**BOARD OF ZONING AND BUILDING APPEALS
THURSDAY, AUGUST 18, 2022 6:00 PM**

1. Briarcliff and Main; Application 2022-5271 (Setbacks); Applicant Charles Schatz; Variance
2. Briarcliff and Main; Application 2022-5271 (Signs); Applicant Charles Schatz; Variance

On behalf of the City of Reynoldsburg, EMH&T conducted a preliminary engineering review of the private development plan for the proposed Caribou Coffee located on the north side of East Main Street, east of Briarcliff Road. The following summarizes our findings and recommendations with respect to this development.

PRELIMINARY PLANS
FOR
EXISTING CONDITIONS, REMOVALS,
SITE, GRADING, EROSION CONTROL,
AND UTILITIES
FOR
CARIBOU CABIN
REYNOLDSBURG, OH

SHEET NUMBER:
C200

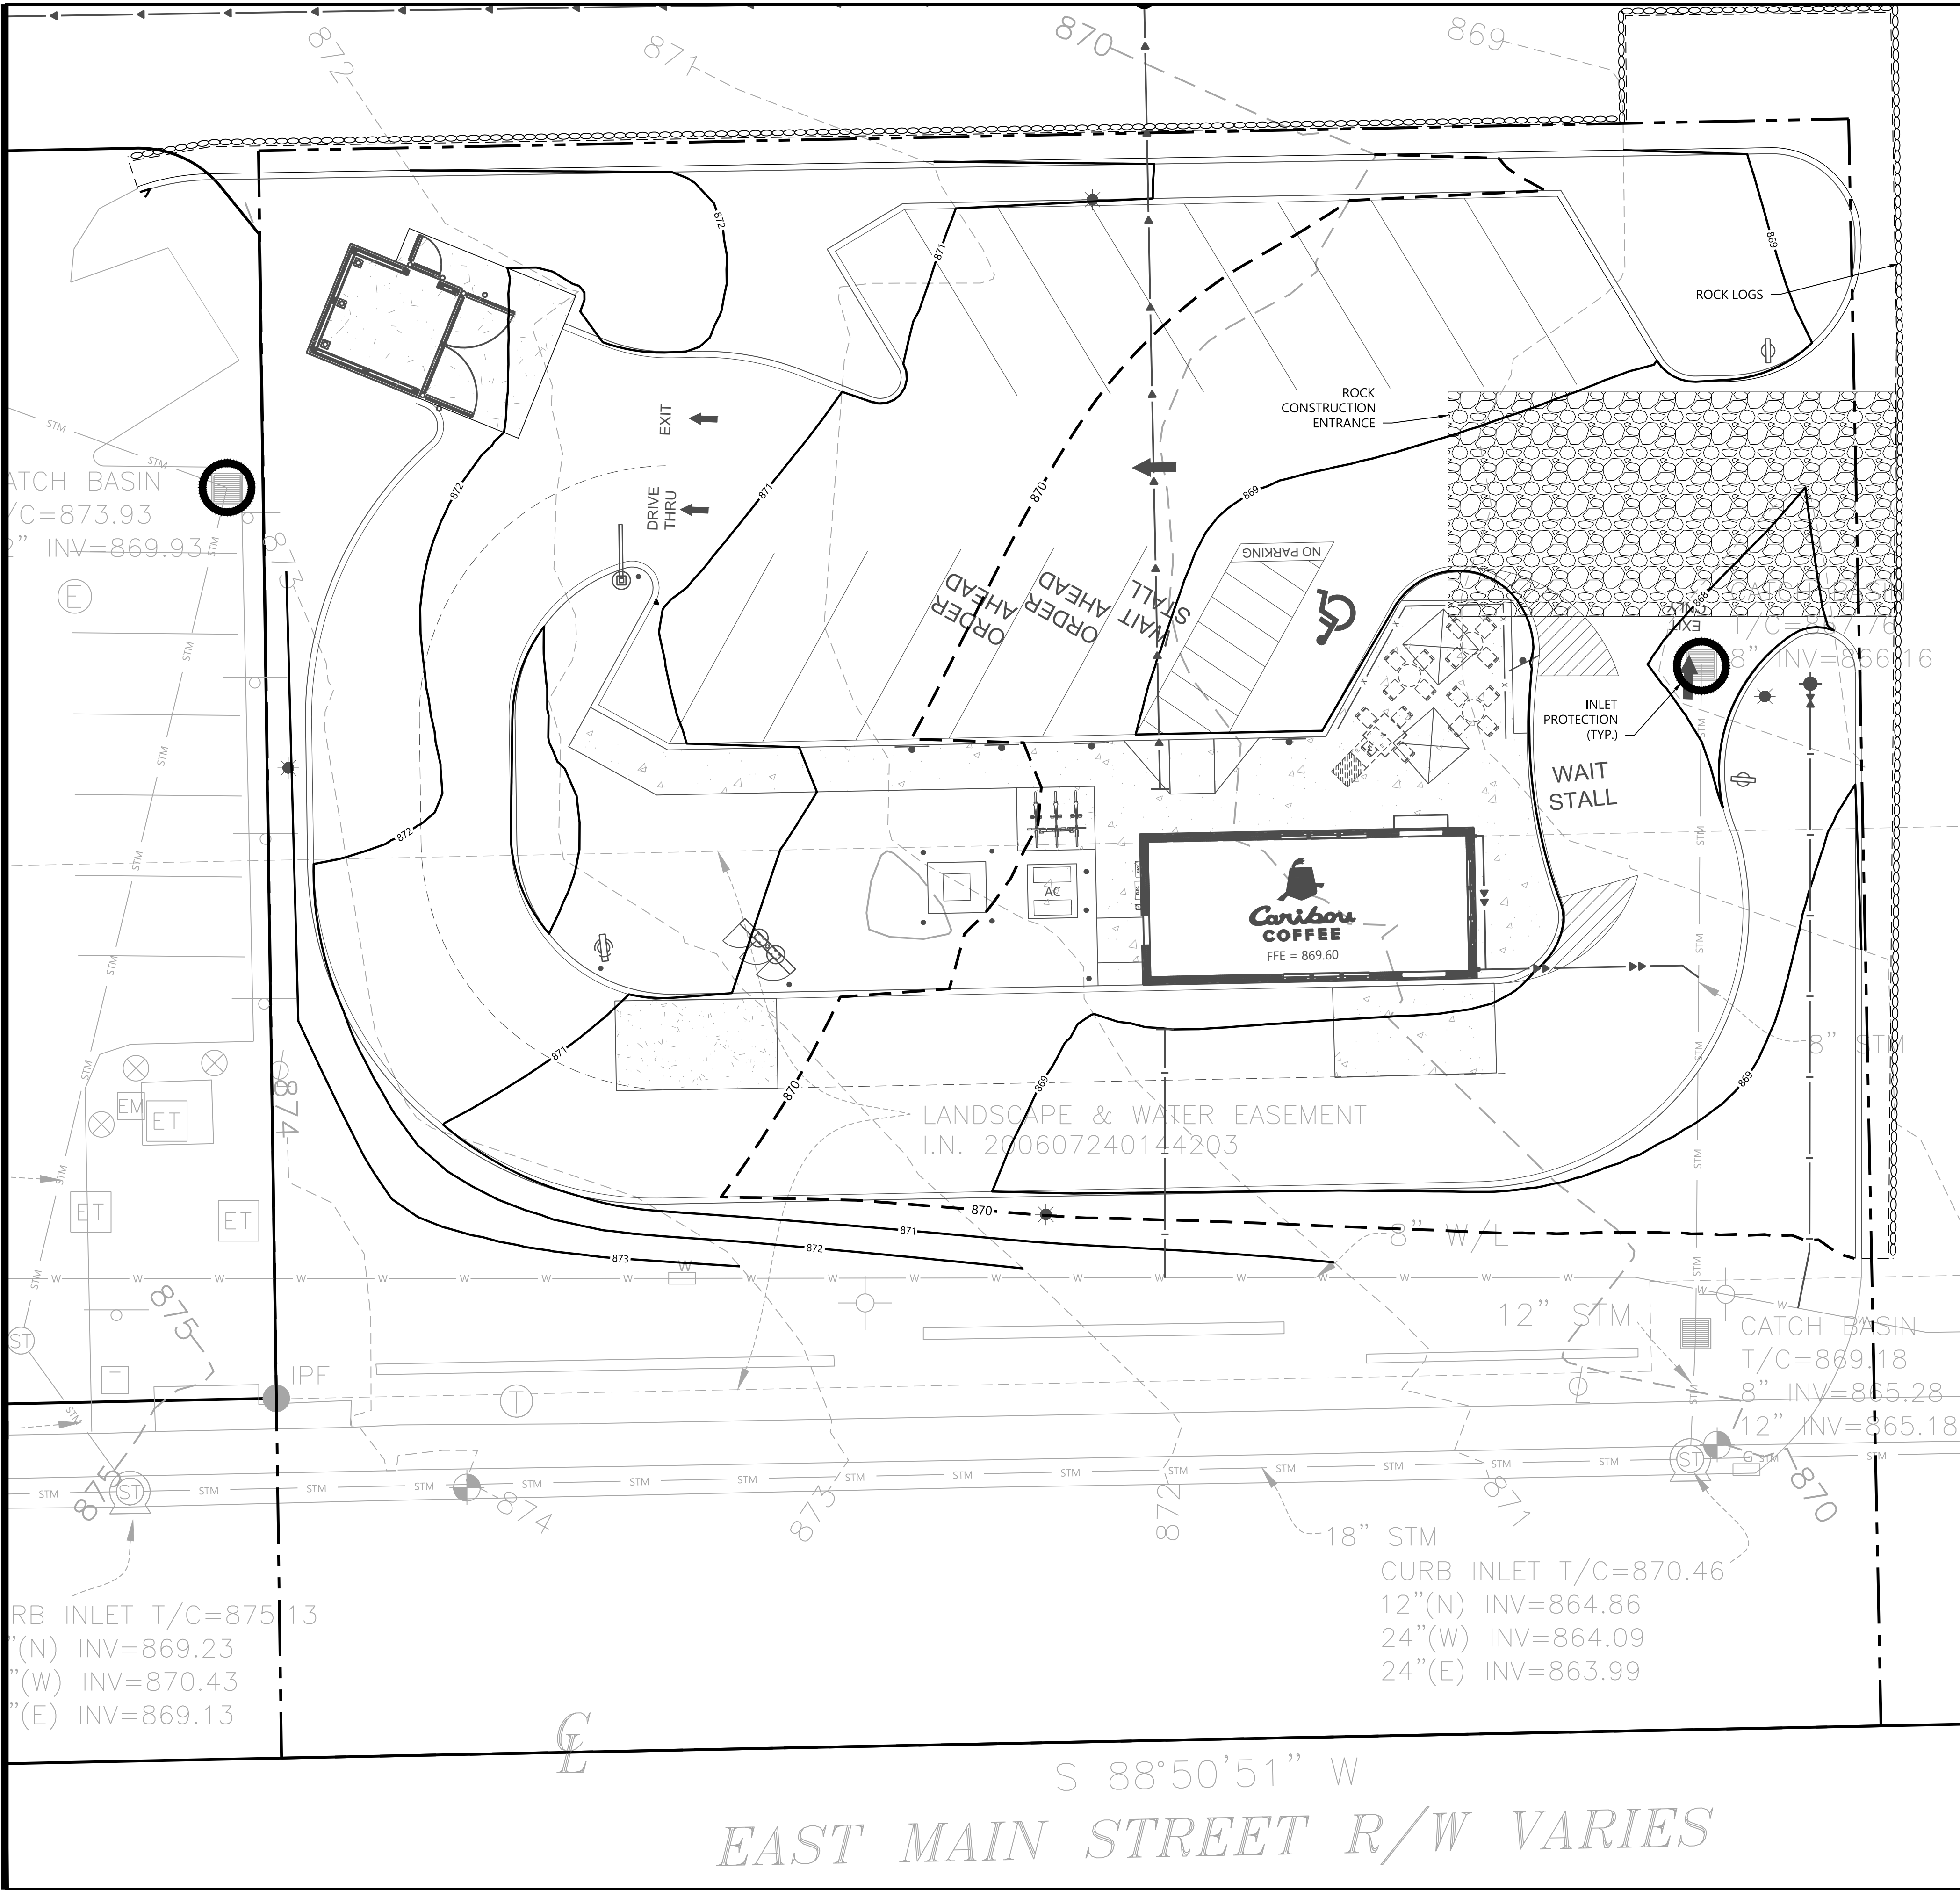
4. The plan shows that 9 vehicles can queue from the pickup window to the ordering station.
5. A sidewalk connection from the right-of-way to the site should be included on the site plan.

6. The site plan proposes 15 parking spaces, which is adequate for the site.
7. The applicant provided an estimate of 350 trips (average daily traffic) for the facility. Although the traffic data requested to determine if a project requires a traffic study references peak hour counts, the provided ADT information is adequate. Since the project is planned to be constructed within an existing commercial center, and with the provided ADT information, a traffic study is not required.

16. Please provide the details for the curb and pavement compositions so they can be reviewed against the City of Reynoldsburg standards. Additionally, the sidewalk that connects to the public walk along East Main Street should be per the Reynoldsburg Standard Drawing R-9.
17. Where applicable, refer to Reynoldsburg Standard Construction Drawings.

GRADING AND EROSION CONTROL PLAN

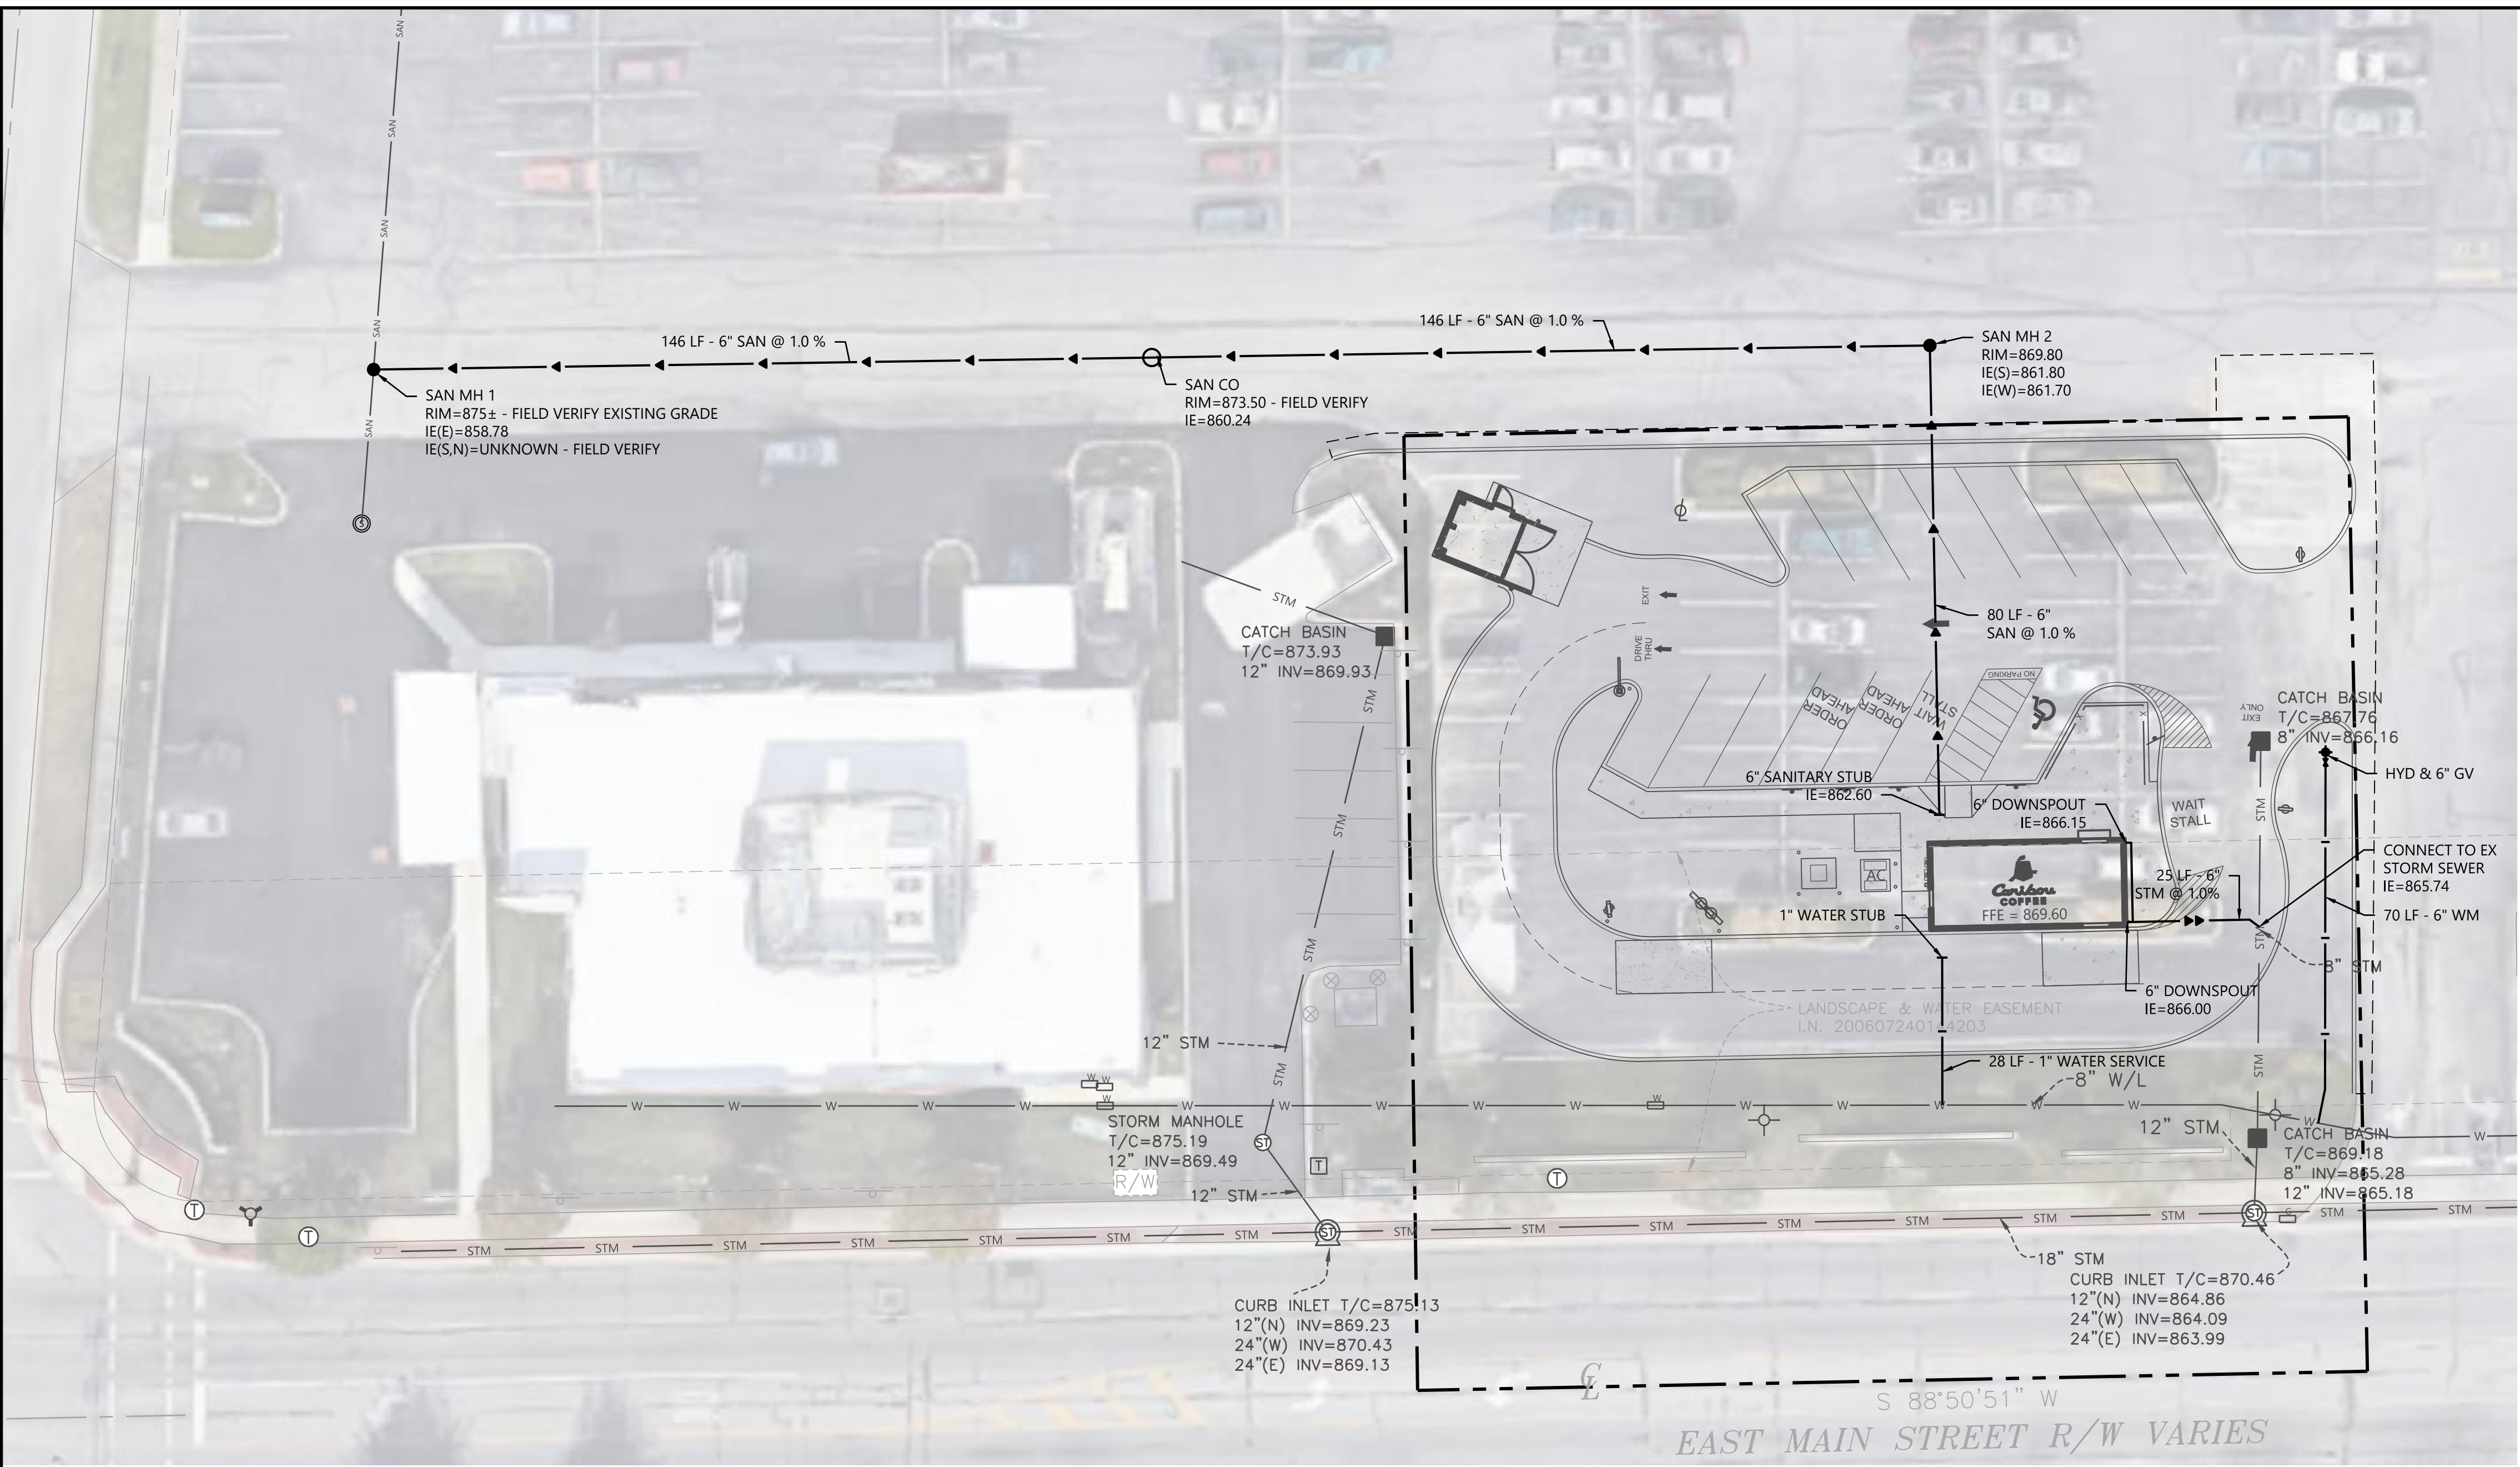
13. The plan shows the site grading from west to east. An existing catch basin and existing storm sewer will accept the site runoff and exit the site near the southwest corner of the site.
14. The plan currently does not show water quality or quantity control features. Since the disturbed area is less than one acre, water quality treatment would not be necessary. Detailed calculations and/or report are to be submitted with the PGU plan to document the pre-and post-developed impervious areas to show if quantity controls are required.
15. The PGU plan will need to show more detailed grading and flood routing information. Storm sewer profile(s) information should also be included.

SHEET NUMBER:
C500

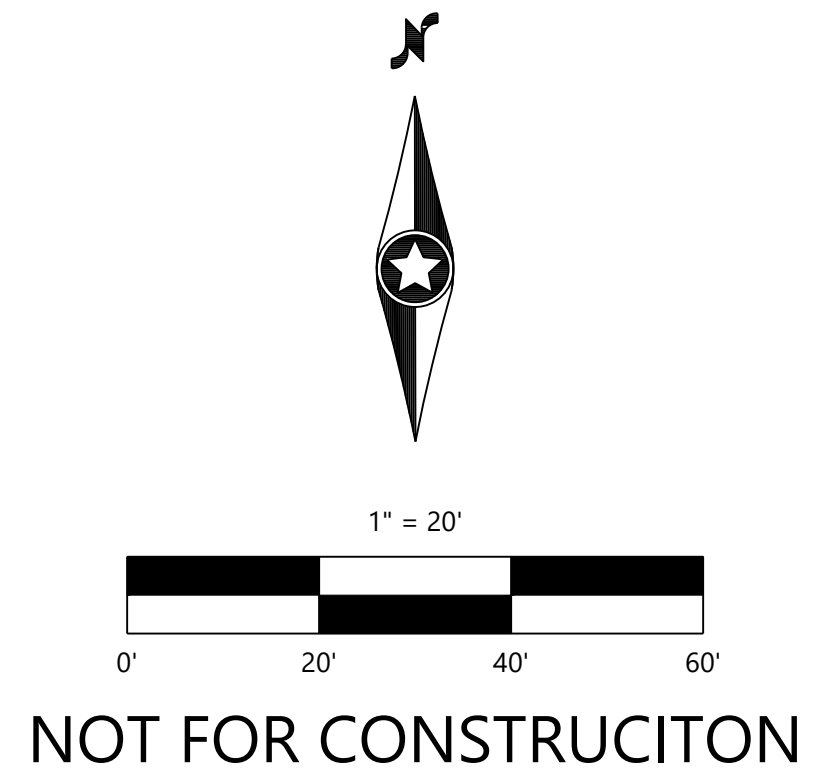
8. For the proposed water service tap and meter, please review and reference the applicable Reynoldsburg Standard Drawings with the PGU submission.
9. The provided utility plan shows a 6-inch sanitary service lateral being extended to the building from the west from an existing 8-inch sanitary sewer (P00345). The lateral shows a slope of 1.0%, which does not meet the required minimum slope of 2.08% for a service lateral. If the required

- a. In addition, the plan is currently showing a manhole on a 6-inch service line which is not allowed. If this remains a service lateral, a cleanout should be placed in the location where the manhole is shown.
 - b. The sanitary lateral also appears to leave the site, extending onto the adjacent property to the north and west. This would require a legal agreement and easement.
10. As shown, the site will be served with water via a new 1-inch tap on the existing 8-inch watermain located on the north side of Main Street (R02479).
 11. A proposed fire hydrant is shown to be installed along the east property line, south of the proposed driveway. This would be a private hydrant and a valve is required at the tee from the existing main.
 12. For lighting, the site is utilizing four light poles with LED lights. Based on photometrics provided, the lighting is adequate for a commercial site.
